**Colorado Springs, CO
Planning and Development**

Final Report - Corrections Required
Application No. DEPN-23-0002

Description : proposing to build (4) 3-story apartment buildings with clubhouse and pool

VETERANS VICTORY - LOT 1 DEVELOPMENT PLAN

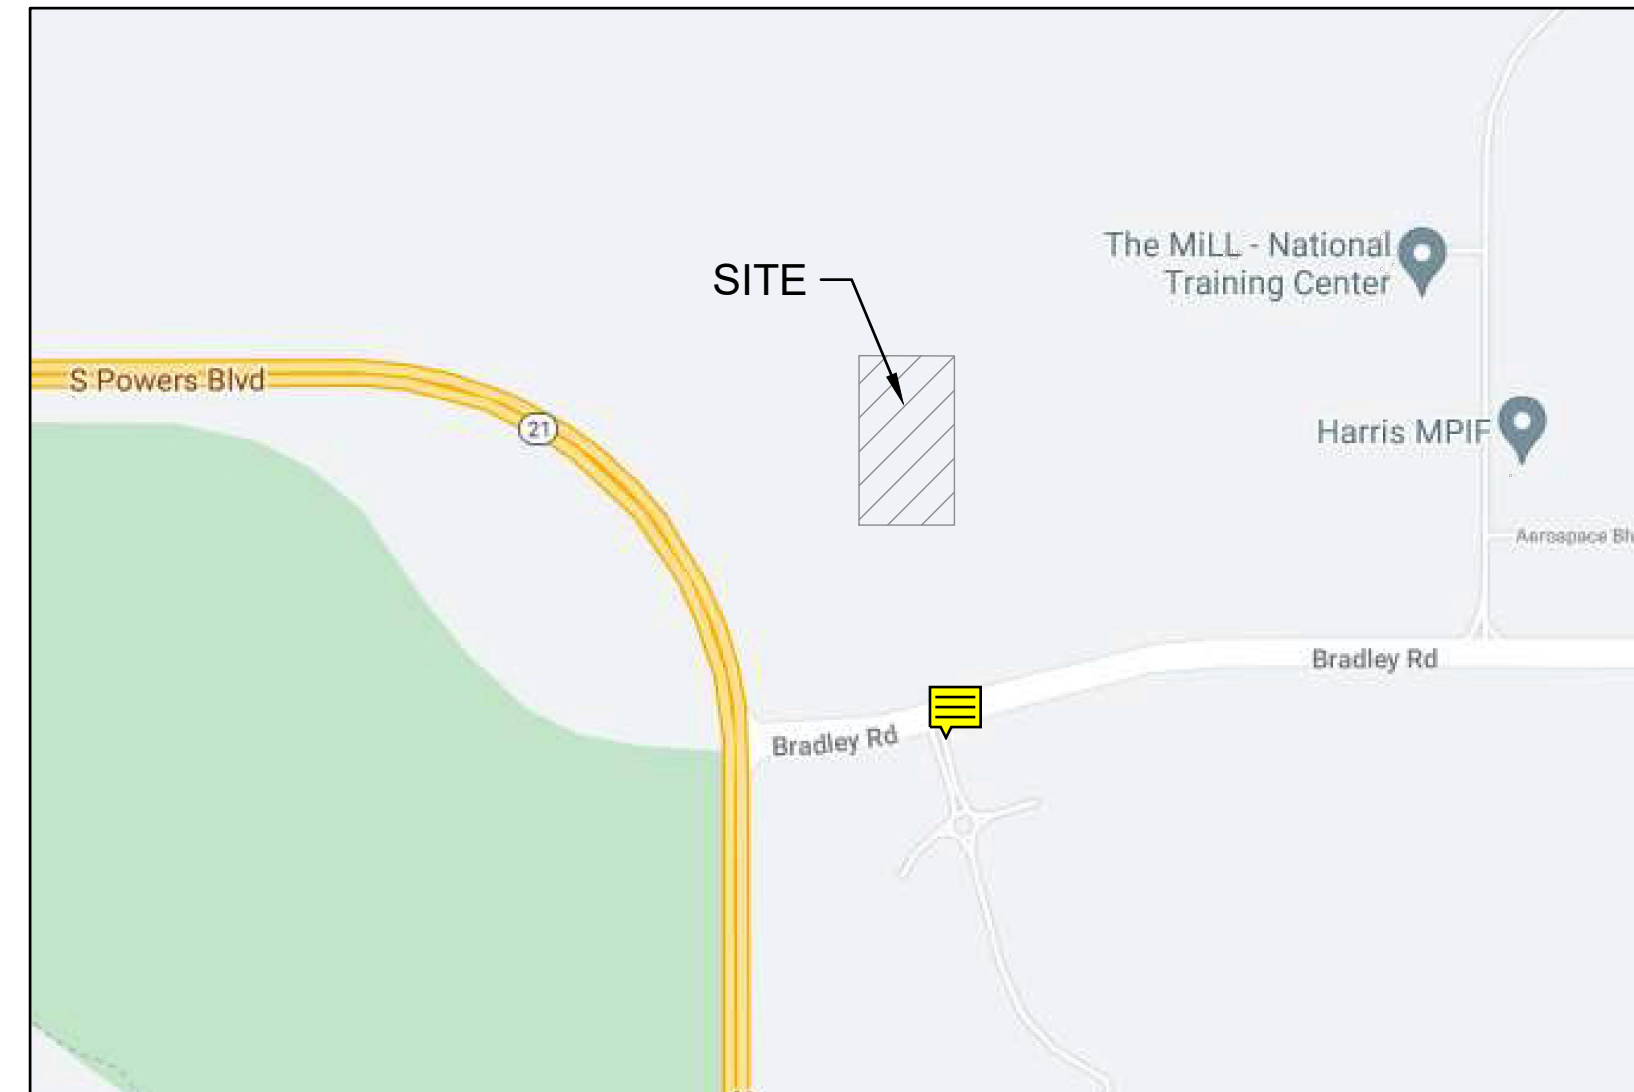
Please clarify, the only, the only submitted document

VETERANS VICTORY - LOT 1
DEVELOPMENT PLAN
SITE PLAN

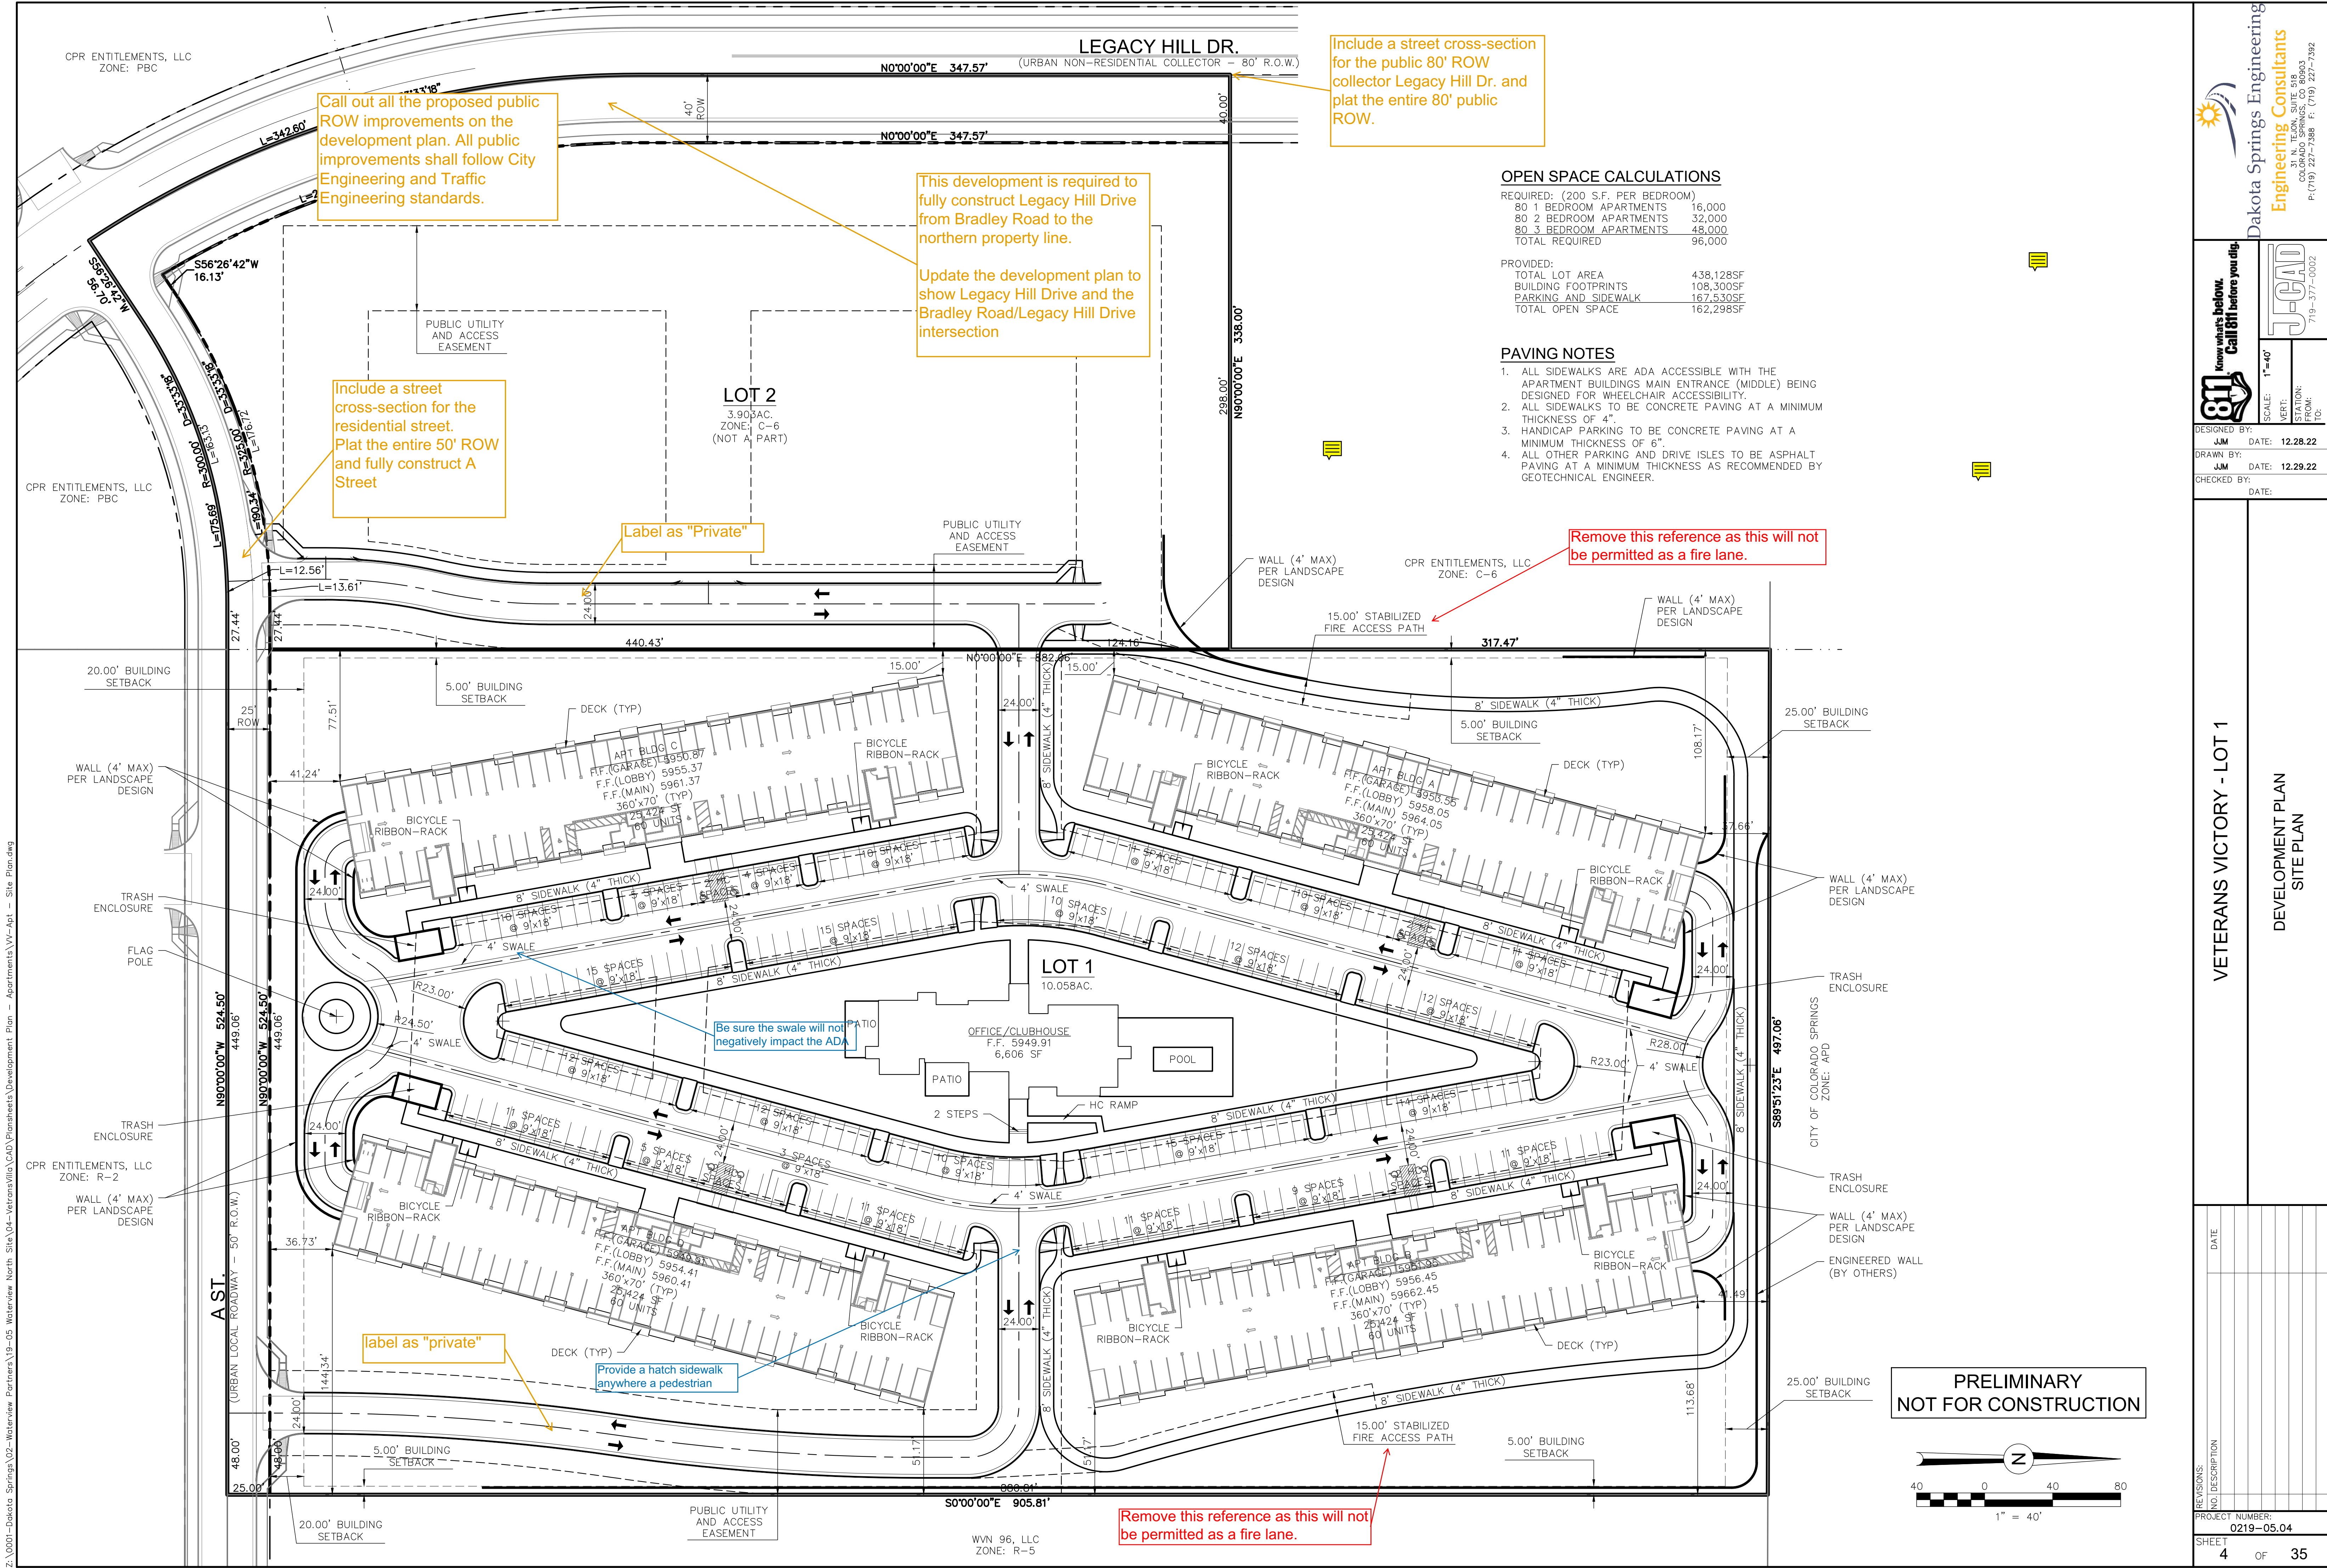
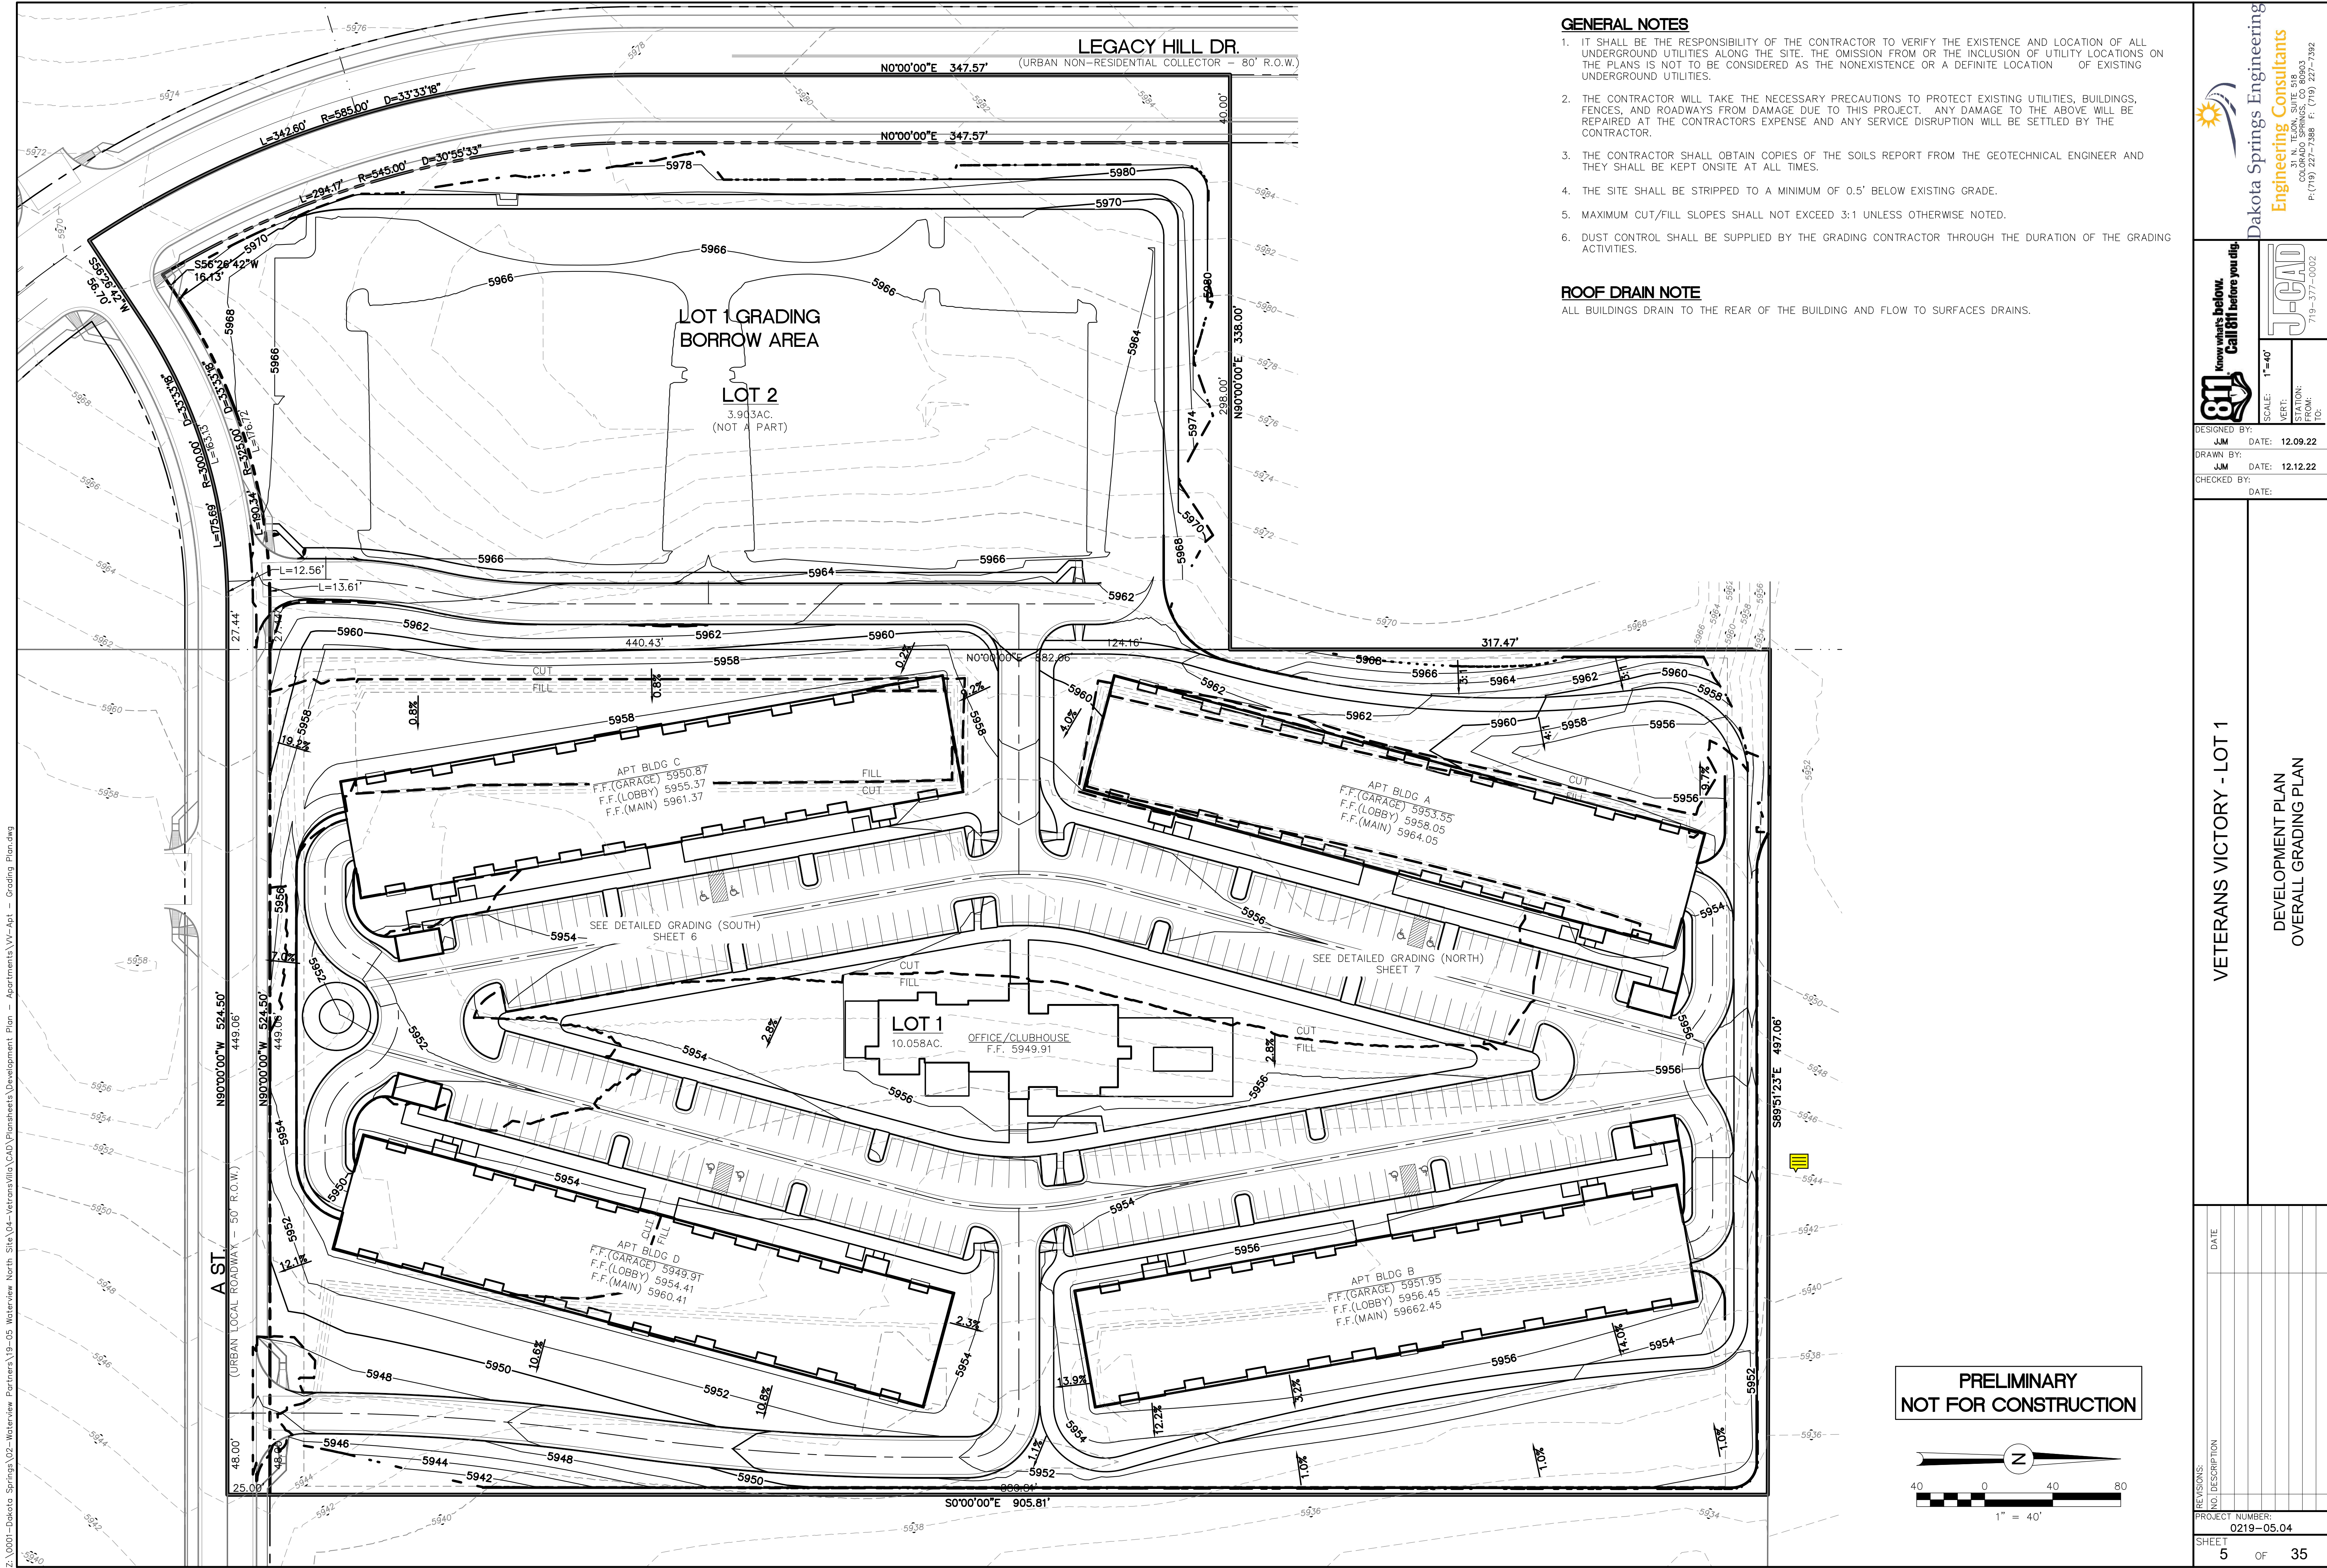
64	13	TJ Gajda : City Engineering - SWENT	Is there a swale to get flows to go to this inlet?
50	14	TJ Gajda : City Engineering - SWENT	Label swales (all)
6	4	Patrick Morris : City Engineering Dev Review	This development is required to fully construct Legacy Hill Drive from Bradley Road to the northern property line. Update the development plan to show Legacy Hill Drive and the Bradley Road/Legacy Hill Drive intersection
7	4	Patrick Morris : City Engineering Dev Review	Include a street cross-section for the public 80' ROW collector Legacy Hill Dr. and plat the entire 80' public ROW.
8	4	Patrick Morris : City Engineering Dev Review	Include a street cross-section for the residential street. Plat the entire 50' ROW and fully construct A Street
9	4	Patrick Morris : City Engineering Dev Review	Label as "Private"
10	4	Patrick Morris : City Engineering Dev Review	label as "private"
11	4	Patrick Morris : City Engineering Dev Review	Call out all the proposed public ROW improvements on the development plan. All public improvements shall follow City Engineering and Traffic Engineering standards.
